# Access Compliance Report

## Public Rights-of-Way

### (Curb Ramps)

Intersection ID: 47574	Main Street: BARRANDS_LN	Cross Street: GAILES_DR	Location: NE
ADA ID: 828D281FD781	Ramp Type: BlendTrans1	Initial Pass/Fail: Fail	Overall Compliance: No
			Severity Score: 21.25

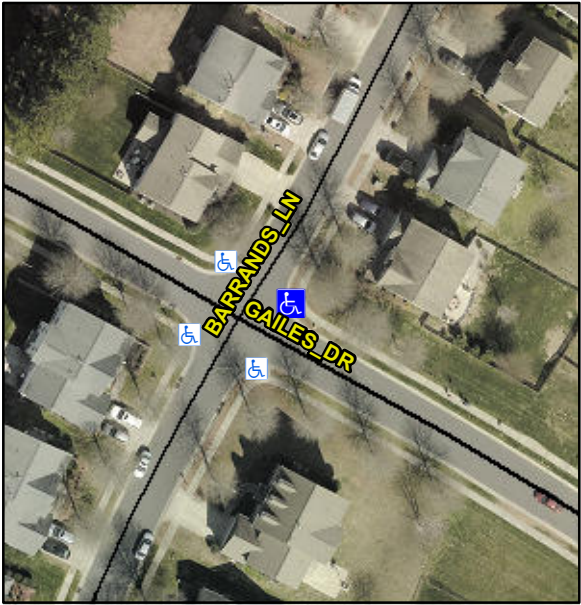
Codes/Mitigation Info/Possible Solution			Field Measurements/Component Compliance			
	Possible Solutions:		<b>Compliance</b>	<b>Description</b>	<b>Data</b>	
	<b>Remove &amp; Replace Curb Ramp With Two New Directional Ramps or Equivalent.</b>		N/A	Ramp Length (in)	48.0	<b>Yes</b>
			No	Ramp Width (in)	47.0	<b>No</b>
			N/A	Flare Type LT	N/A	N/A
			N/A	Flare Slope LT (%)	N/A	N/A
			N/A	Flare Traversable LT?	N/A	N/A
			N/A	Landing Length (in)	N/A	N/A
			N/A	Landing Width (in)	N/A	N/A
			N/A	Landing Slope (%)	N/A	N/A
			N/A	Landing X Slope (%)	N/A	N/A
<p>Surveyor Notes:</p> <p><b>N/A</b></p> <p>PROW/ADA:</p> <p><b>R304.5.1, R304.5.3</b></p>			N/A	Flare Type RT	N/A	N/A
			N/A	Flare Slope RT (%)	N/A	N/A
			N/A	Flare Traversable RT?	N/A	N/A
			N/A	DWS Provided?	N/A	N/A
			N/A	DWS Contrast?	N/A	N/A
			N/A	DWS Length (in)	N/A	N/A
			N/A	DWS Full Width?	N/A	N/A
			N/A	DWS Offset (in)	N/A	N/A
			N/A	Shared Landing?	N/A	N/A

N/A	Gutter Ponding?	N/A	N/A
			N/A	Gutter Lip Ht (in)	N/A	N/A
			N/A	Painted X Walk1?	No	N/A
				X Walk 1 Direction	To NW	
				X Walk 1 Width (in)	N/A	
				X Walk 1 Slope (%)	1.7	
				X Walk 1 X Slope (%)	5.1	
			N/A	Ramp inside XWalk1?	N/A	N/A
				Road Slope (%)	4.2	
				Road X Slope (%)	1.0	N/A
			N/A	Any Obstructions?	N/A	N/A
Total Cost:		\$ 3200.00		Obstruction Type		
					N/A	N/A
					Yes	Surface Condition? (G/P)
					N/A	Curb Slope (%)
